RESPONSE TO WORKING GROUP AND PUBLIC COMMENTS ON THE SITE C CLEAN ENERGY PROJECT ENVIRONMENTAL IMPACT STATEMENT

Technical Memo

PEACE ATHABASCA DELTA

MAY 8, 2013

Figure 3 **Duration Curves of Simulated Flow/ Water Level at Peace Point With and Without Site C**

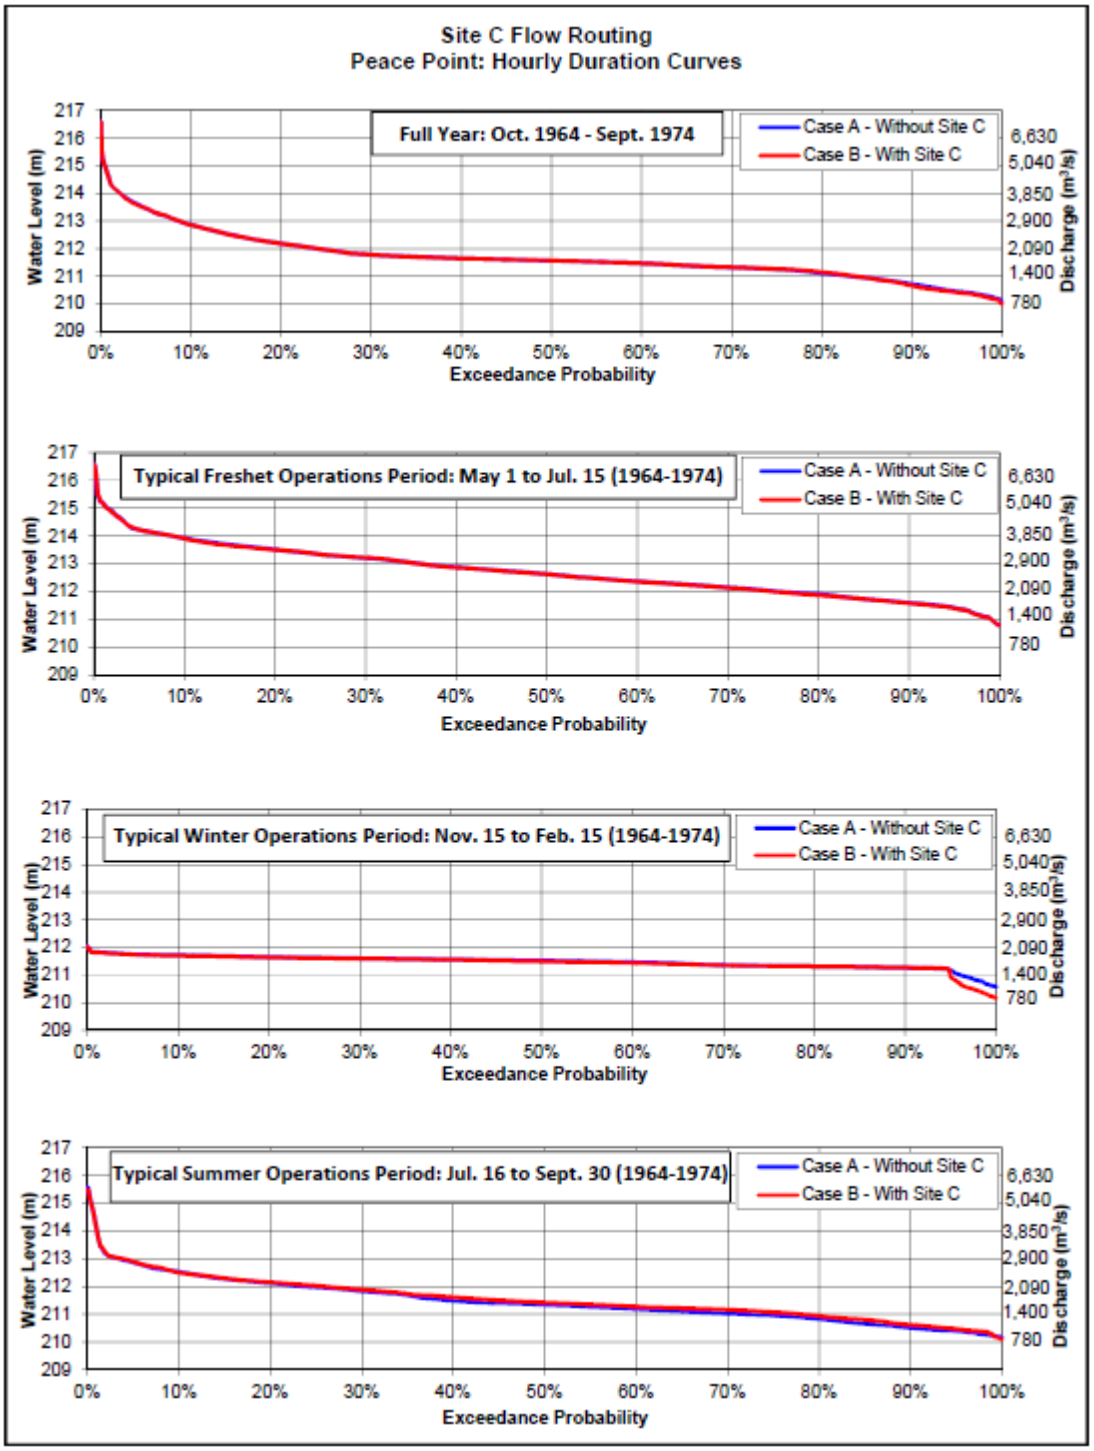
A number of comments have been received during the Comment Period regarding the need for the inclusion of the Peace Athabasca Delta (the "PAD") in the spatial scope of the environmental assessment for the Project. These comments include:

1) The scope of the assessment should extend to the PAD due to potential alterations in ice formation, ice break up/jamming and flood regime
2) The scope of the cumulative effects assessment should extend to the PAD
3) The Project could have an effect on the exercise of treaty rights and other traditional use of the PAD by Aboriginal peoples
4) The PAD should be a valued component

At Peace Point (the downstream extent of the surface water regime study, located approximately 40 km upstream of the PAD), negligible change in surface water regime is predicted as a result of the Project compared to the natural variability of the surface water regime at that location. This assertion is further explained in the Spatial Boundary Selection Technical Memo. Annual and seasonal duration curves of hourly flow/ water level with and without the Project were provided in the EIS and are attached for reference (see Figure 3). Additional duration curves of hourly flow at Peace Point for the ice freeze-up and break-up periods (taken as the month of November for freeze-up and the period April 15 to May 15 for break-up) are also attached to better illustrate the predicted influence of the Project during those particular periods (see Figures 4 and 5).

At Peace Point, the downstream extent of the hydraulic model (approximately 1,030 km downstream of the Site C dam site), Figures 3, 4 and 5 illustrate that the duration of any particular flow/water level both with and without the Project are very similar. The only notable predicted change is a small increase in the frequency of low flows with the Project in the typical freeze-up period. The possibility of a relationship between the freeze-up stage (water level) and the probability of dynamic break-up and ice-jams in the spring has been researched[12]. The probability of ice jamming would not be influenced by the relatively lower flows that are predicted to occur periodically during the freeze-up period with the Project. Ice cover that forms at a low level during a period of relatively low flow in November would re-freeze at a higher level as flows increase in December. The change in freeze up levels occurs because with increasing flows, the floating portion of the ice cover in the main channel releases from the border ice attached to the banks, floats up to accommodate a higher flow beneath it, and re-freezes to the banks at a new, higher freeze-in level[13]. Consequently, the predicted small increase in the frequency of lower flows in November would not effect the frequency of ice-jams in the lower reaches of the Peace River. The timing and magnitude of ice-jamming would also not be influenced by the Project.
